MIDWEST POOLED FUND PROGRAM

Progress Report - First Quarter 2010 January 1st to April 2nd

Pooled Fund Consulting Summary

This is a brief summary of the consulting problems presented to the Midwest Roadside Safety Facility over the past quarter and the solutions we have proposed.

Figure 6. IL Tollway Standard B18-01

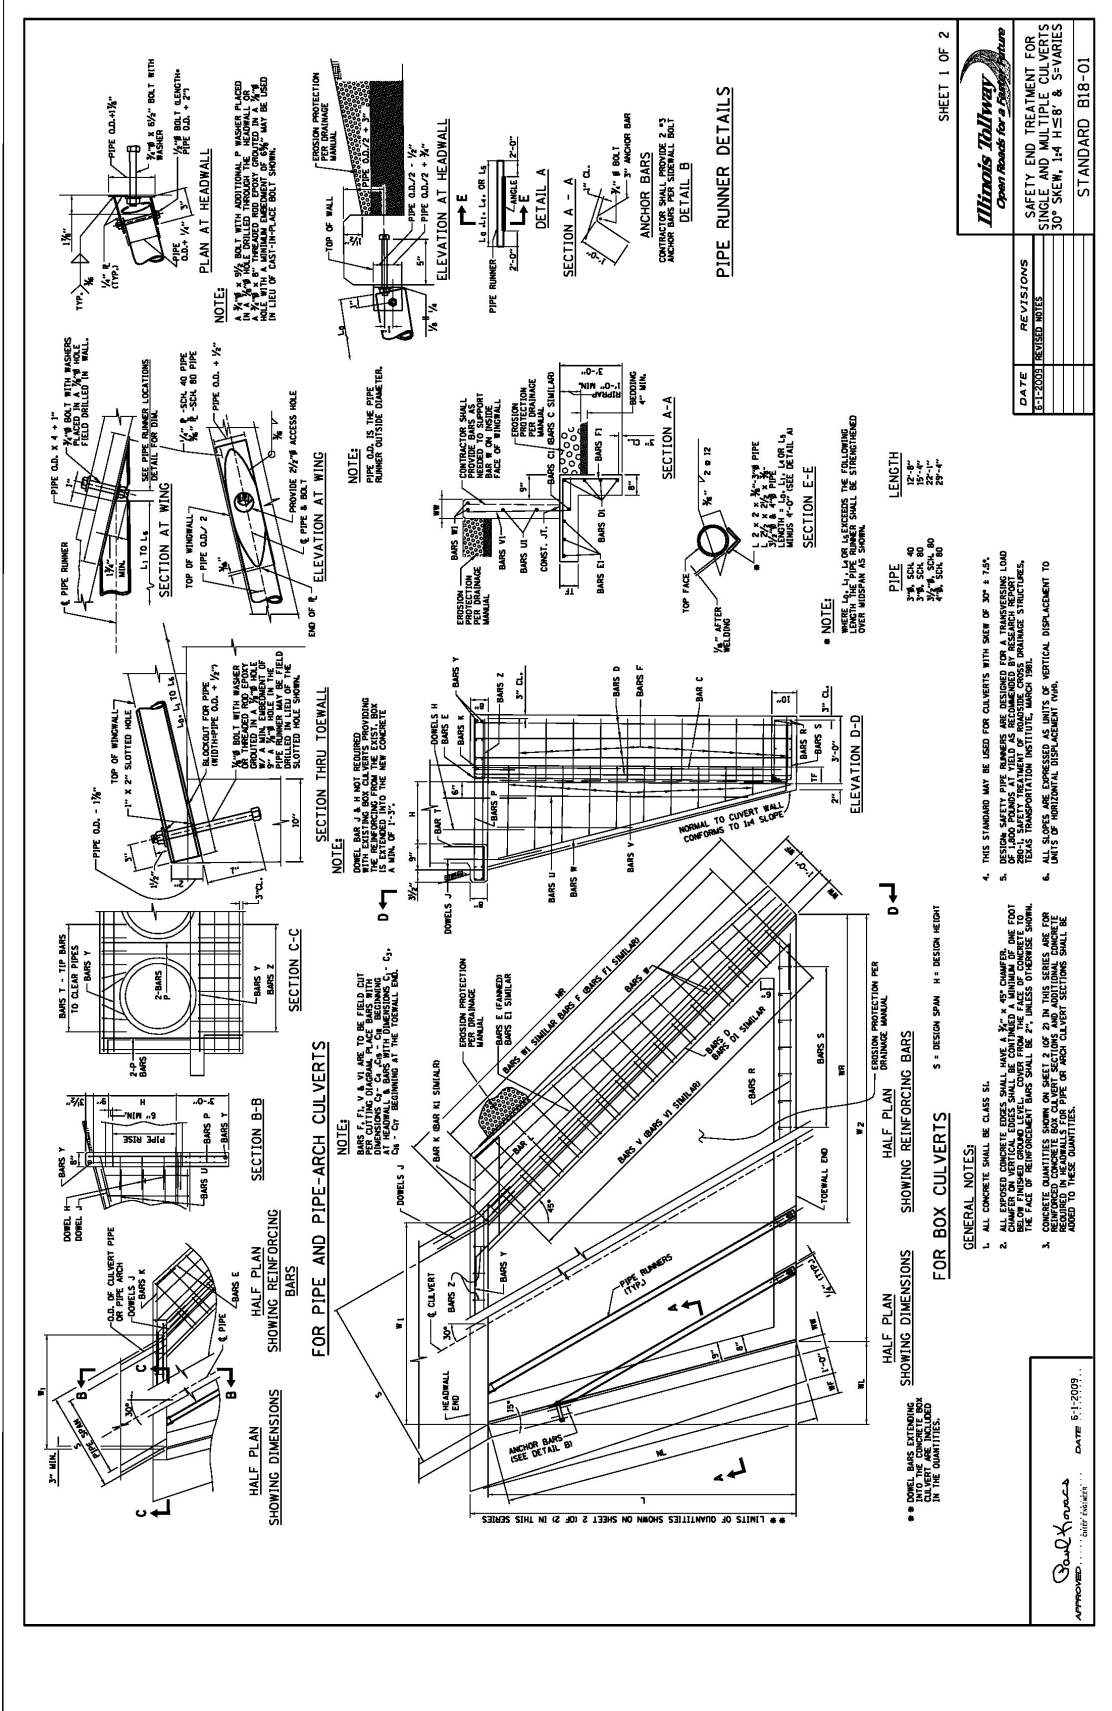
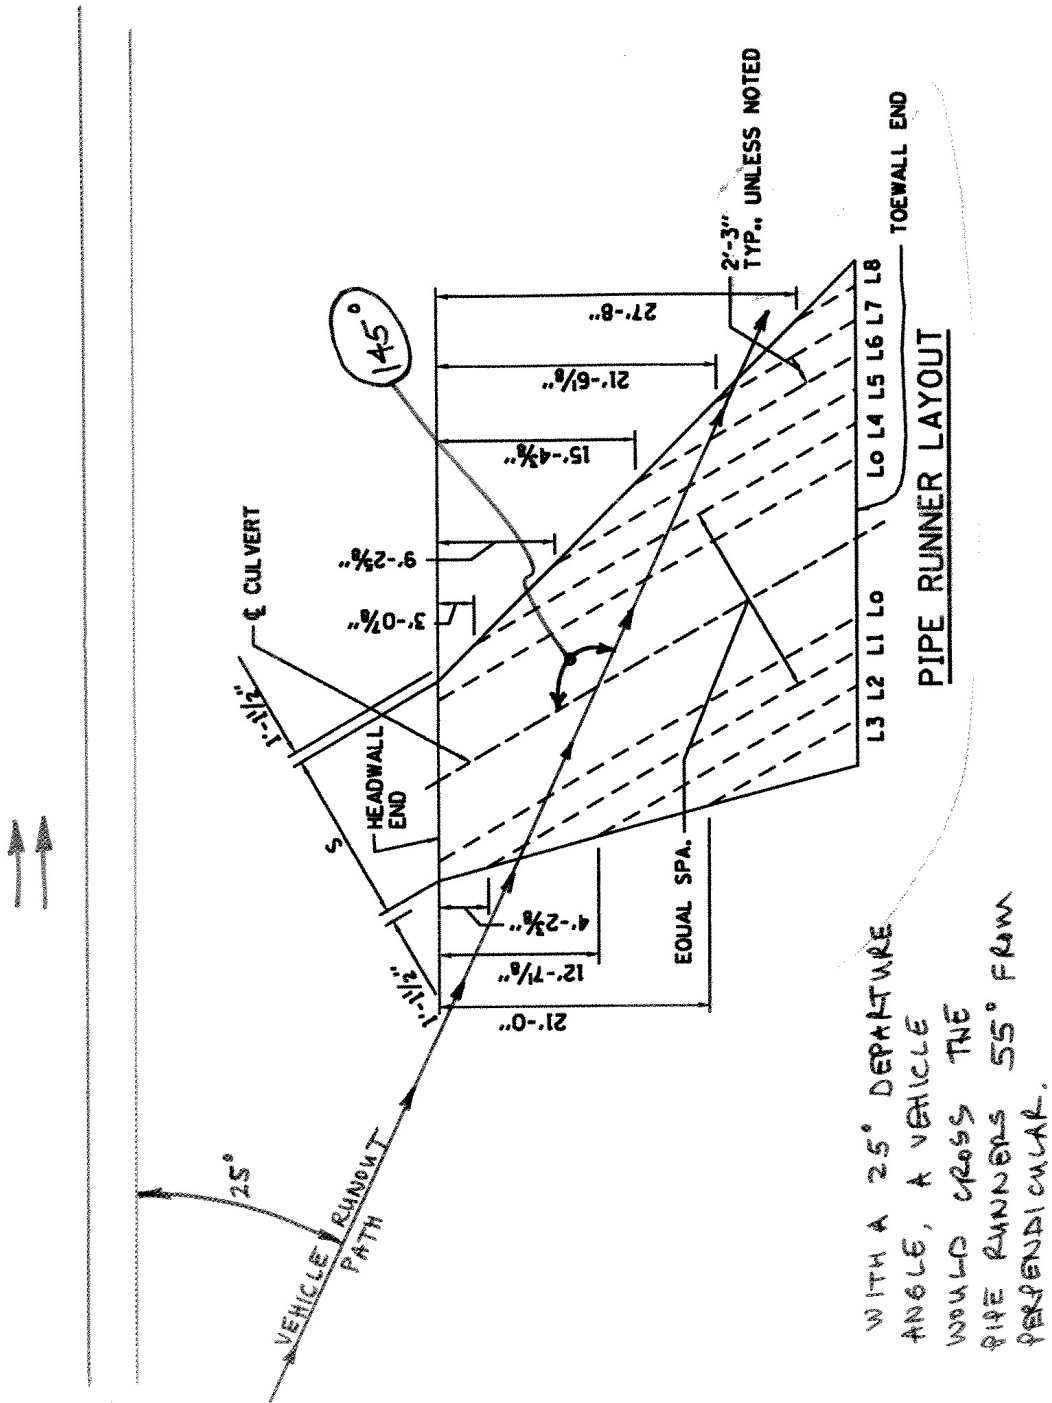
I am looking for guidance on the use of pipe runners at skewed culverts. The current IL Tollway standards show pipe runners perpendicular to the roadway when the pipe is perpendicular to the roadway. Based on a departure angle of 25 degrees, a vehicle leaving the road would hit the pipe runners 25 degrees from perpendicular. For our skewed pipes and headwalls, the pipe runners are shown parallel to the pipe. Therefore for a culvert that is on a 30 degree skew (right hand forward) with pipe runners parallel to the pipe, that same vehicle departing at 25 degrees would now hit the pipe runners 55 degrees from perpendicular. This seems like too much of an angle. I was under the impression that the pipe runners should ideally be perpendicular to the path of the departing vehicle. Is there guidance for usage of pipe runners on skewed pipes?

Figure 9. 54" TL-5 Concrete Barrier

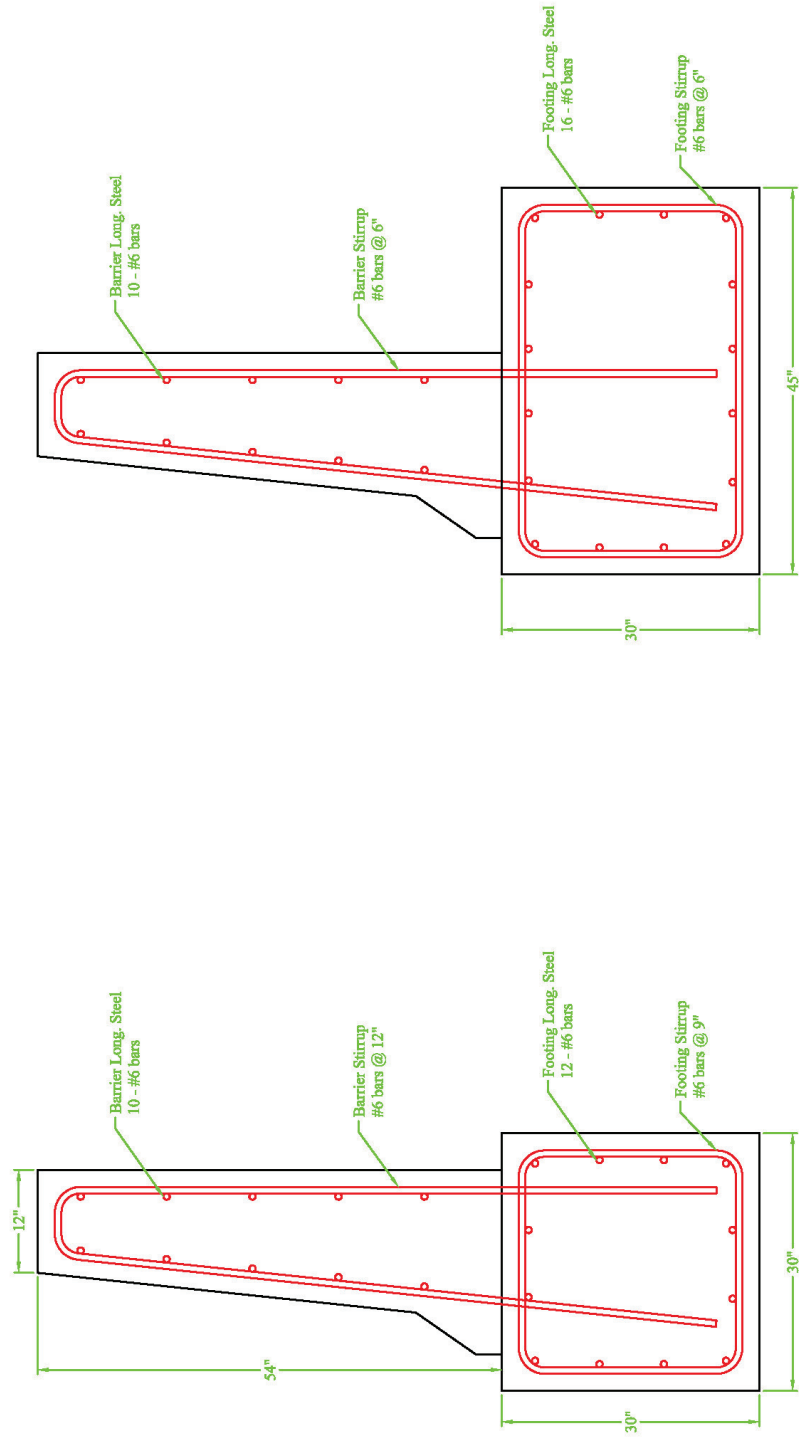
From the Roadside Design Manual we note that the F-Shape may be extended to a taller configuration by “following the slope of the upper face if the barrier is thick enough or adequately reinforced at the top, or the extension may be vertical” (6.4.1.7). However, this would not be adopted directly from the 51 inch barrier as provided in the 2004 work, but would appear to require some modification to the barrier and footing design.

- Adaptation of the footing for either of the 42 inch tall barriers to meet Illinois requirements (weaker soils, freeze thaw considerations).
- Modification of the 51 inch F-shape to a 54 inch height and with modifications to the footing design to accommodate this, plus the Illinois footing conditions.

See the attached PDF file for a simplified drawing for a 54" tall, F-shape, TL-5 barrier. A few notes:

1. The only difference between the interior and ends sections for the barrier is the reduction of stirrup spacing from 9" to 6".
2. All longitudinal steel should be evenly spaced
3. 10 of 12 longitudinal steel bars in the interior footing can continue through the end section footing as well. The remaining two bars should be extended at least 2 feet into the end footing.
4. The end section shows the barrier positioned on the front of the footing, but it could be placed on the backside of the footing as well.
5. Other footing dimensions can be created to provide adequate strength, however the steel reinforcement may need to be reconfigured.

MWTSP Testing Series Successfully Tested MGS Approach Transition

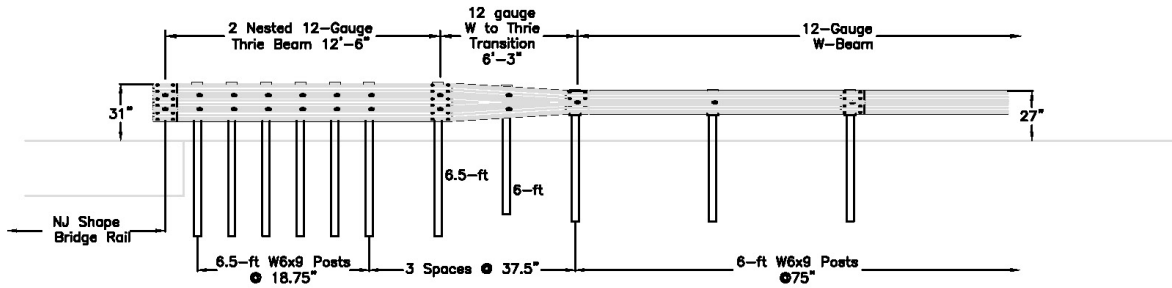
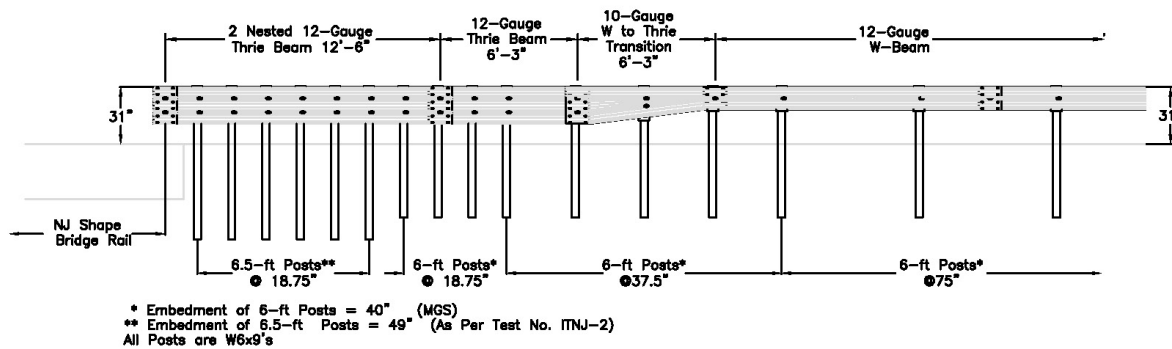
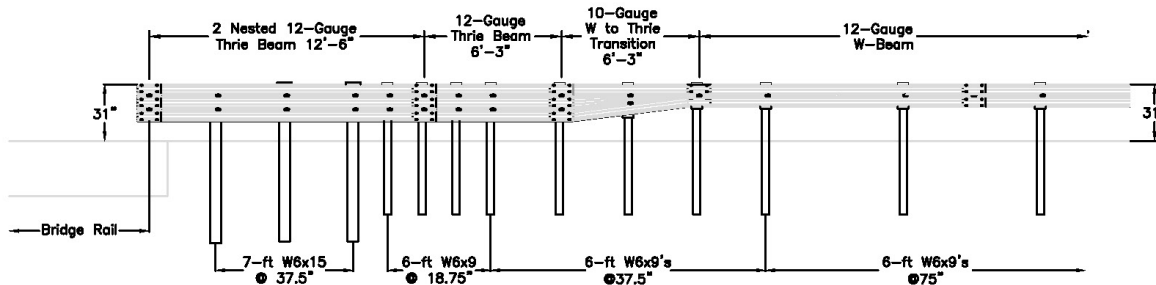
1. Do we substitute only the last 12’-6” of the Alaska Design into the last 12’-6” of the MwRSF tested option?
2. For the MwRSF tested transition, the next section upstream of the double nested 12’-6” segment is a 6’-3” single thrie beam section. The post spacing drops to a quarter post spacing (18 ¾”) as it approaches the double nested 12’-3” section, so do we need to add one additional post into the Alaska design between posts A6 and A7 so there is a consistency in the progressive stiffness of the system?

3. In the car crash test, I noted significant snagging of the vehicle as it impacted in the area of the asymmetric w-beam to thrie beam section, although the test was a pass. Would it be prudent to add one additional half post spacing between posts M11 and M12? This would essentially be option “L” I believe. Although the Pooled Fund voted to test option “K” since it would require one less post, I remember you guys were much more confident of option “L” passing.

The top design is of the Iowa transition, very similar to the one you submitted
The bottom design is the tested MGS approach transition – Design K.
The middle design is the Iowa transition with the approach (upstream) transition considerations.

Hopefully the middle design answers your questions about how to attach the approach (upstream) transition to your existing transition. If you need anything else, please let me know.

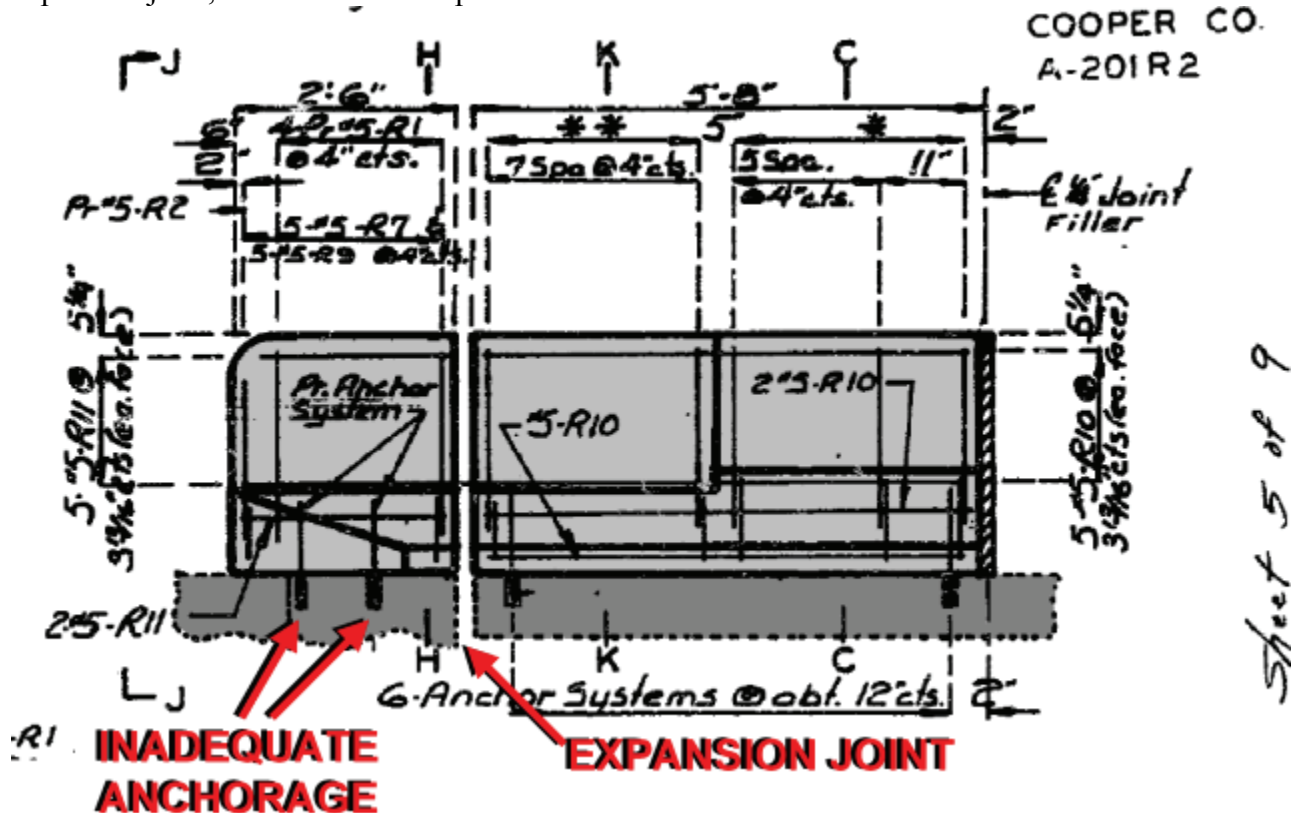
We have an old bridge on I-70 which, at one point in its life, was rehabed and new safety barrier curbs added. In order to attach the bridge anchor section of guardrail without spanning the expansion joint, a stand-alone end post was cast and the rail attached.

We believe the post was insufficiently anchored because subsequent hits on the rail have caused it to move out significantly. Obviously, we're concerned about future pocketing and know we have to fix it. I don't want to repair this setup because I don't believe it functions as well as it could, and, as these photos show, there isn't a lot of substrate to attach to.

I am also copying Phil TenHulzen on this email since he may be able to provide you with the NDOR CAD details for this transition system.
